## MODIFICATION BULLETIN NO. 1

Model	LCT / Duplex Unit for C4MF	Volt/Hz	Date of Modification	Serial Number
Modified Article	Parts Catalog			
Reason for Modification	Parts catalog correction

Model	LCT / Duplex Unit for C4MF	Volt/Hz	Date of Modification	Serial Number
Modified Article	Microswitch and LED Sensor Type - T			
Reason for Modification	Parts standardization

Model  Modified Article  Reason for  Modification		LCT / Duple:	x Unit for C4MF					Volt/Hz	Date of Modification	Se Nun	rial nber
Me			Reverse Roller Drive Shafts									
			To reduce rumbling noise									
Draw	Old Parts		New Parts	Description	Rank	Q'ty Used	Inter- change-	Parts neede	d for replacem	ent by new part	Pa Cat	rts alog
No.	No.		No.	Description	IXalik	Old→New	ability	Part No.	Description		No.	Page
	A3052692		A3052686	Reverse Shaft		1 → 1	X/O				23	9
	06320100G			Pin - M2 x 10		1 → 0					108	9
	08053145 -			Ball Bearing - 6 x 12 x 4mm		1 → 0					107	9
	AA140370		A3052687	Reverse Drive Shaft		1 → 1	X/O				24	9
	06320100G-			Pin - M2 x 10		1 → 0					108	9

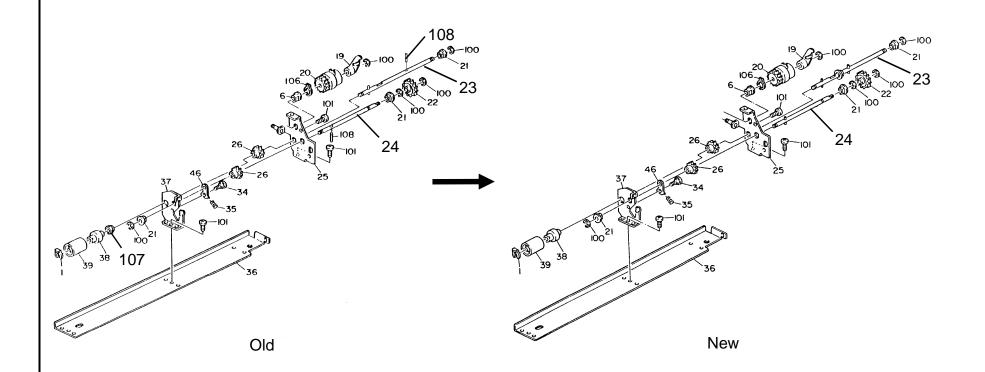
The cylindrical pins on the reverse roller drive shafts have been changed to spring pins. To facilitate servicing, the assembled parts will be supplied as service parts in stead of the individual parts as shown below.
